RE: Response to NYSDEC Comments and Revised Site Cover Pre-Design Sampling Plan  
800 Hiawatha Blvd. West  
NYSDEC Brownfield Cleanup Program (BCP) Site No. C734083  
JMT Job No. 16-S0140N

# REVISED SITE COVER PRE-DESIGN SAMPLING PLAN

**800 HIAWATHA BLVD.  
SYRACUSE, NEW YORK  
BCP SITE NO. C734083**

PROJ. No.: 16140 DATE: 10/2025 (Revised) SCALE: 1"=80' DWG. NO. \_\_\_\_\_ FIGURE 1

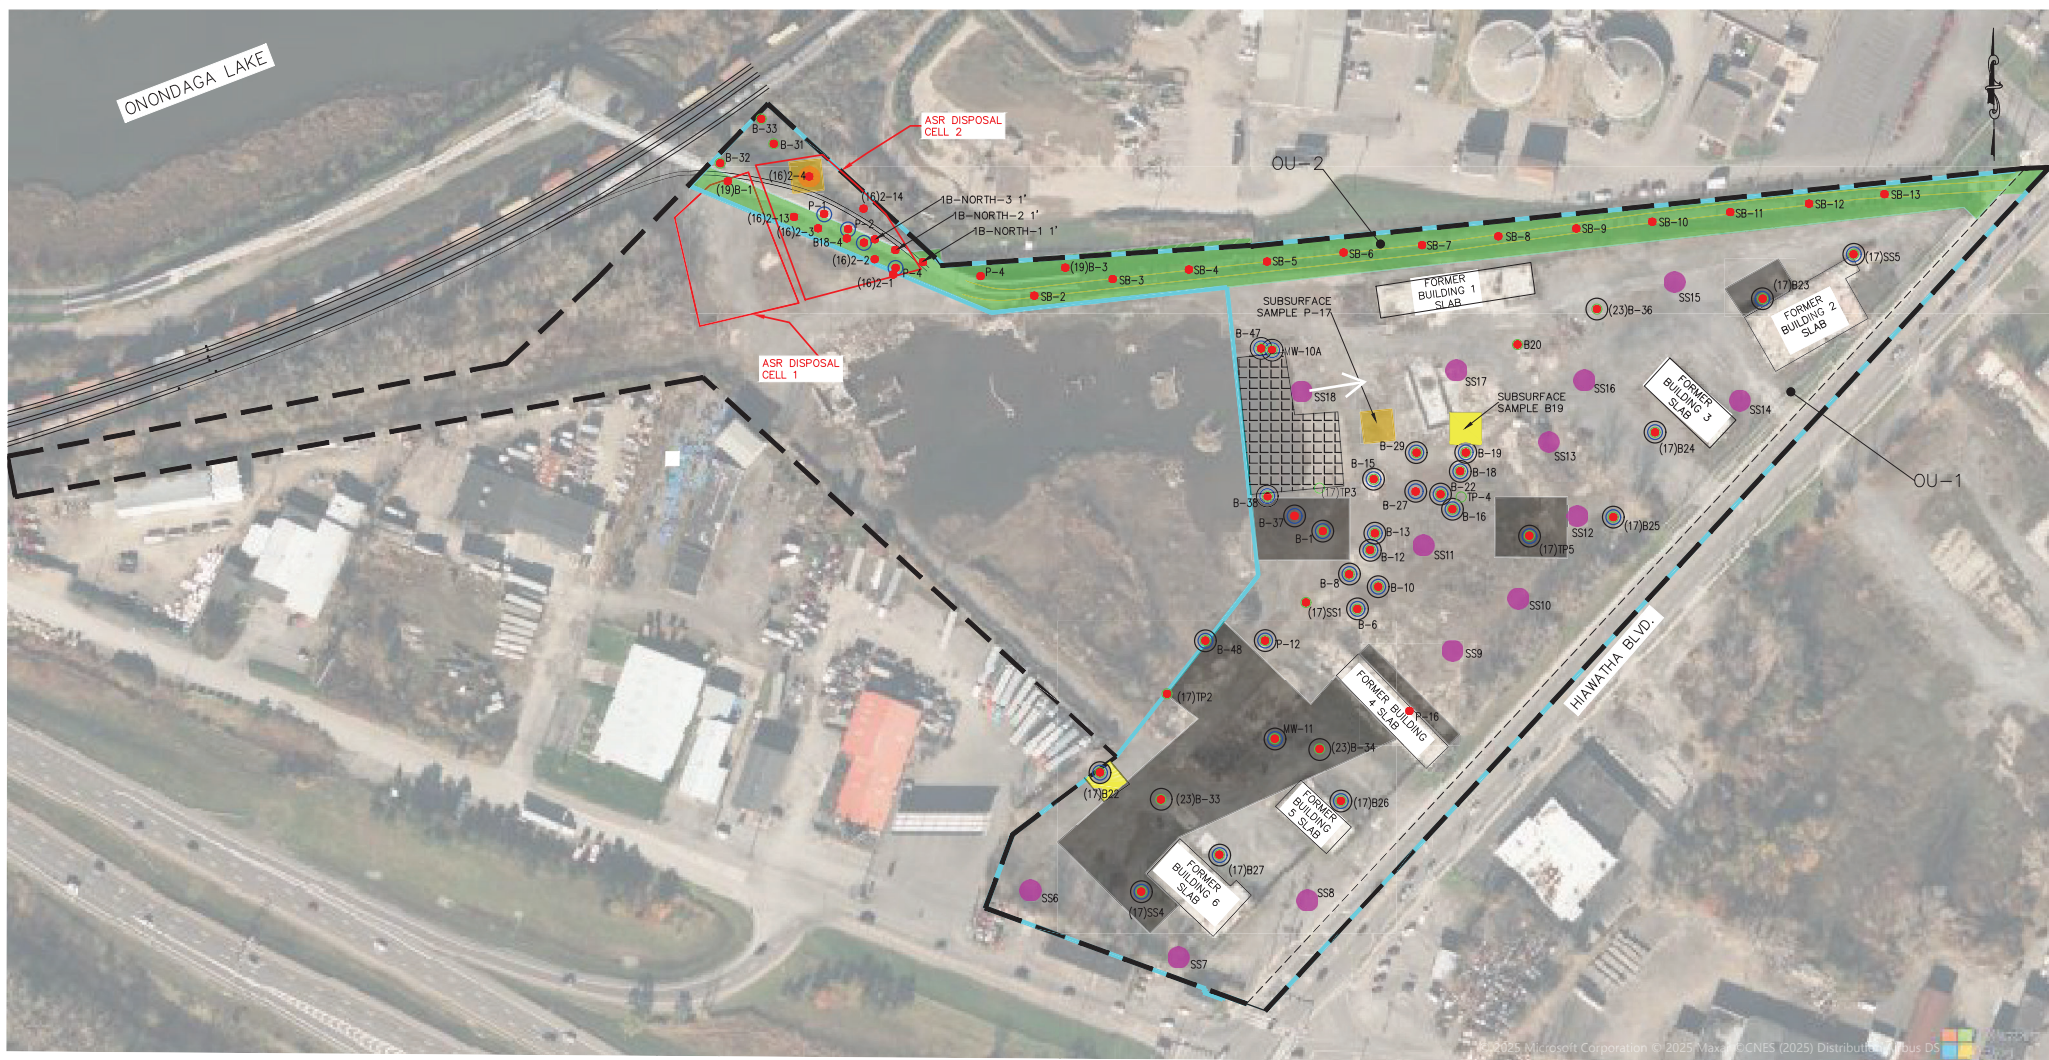
- The third sentence must be rewritten as follows: "Additional surface soil sampling will be conducted at 13 locations in OU-2 to further define the lateral extent of the soil cover (see Figure 1). Surface soil samples will be collected from 0 to 2 inches and from 2 to 12 inches.

**Comment 4:**

Figure 1:

- OU-2 must be labeled; and
- The labels for samples collected by JMT in 2017 and in 2023 must be prefaced with the year they were collected so as not to confuse them with historical sample locations. For example, "B19" must be replaced with "(17) B-19" and "B24" must be replaced with "(23) B-24".

**Response 4:** Acknowledged. The July 29, 2025 work plan shows OU-2 as the green area in Figure 1. It was labeled "OU-2 Remediated Area" in the legend. In the revised work plan, the green symbol label is now "OU-2" in the legend and a "Note 3" has been added to the figure to indicate that OU-2 has been remediated. The sample label adjustments to Figure 1 now reflect the collection year per the comment.
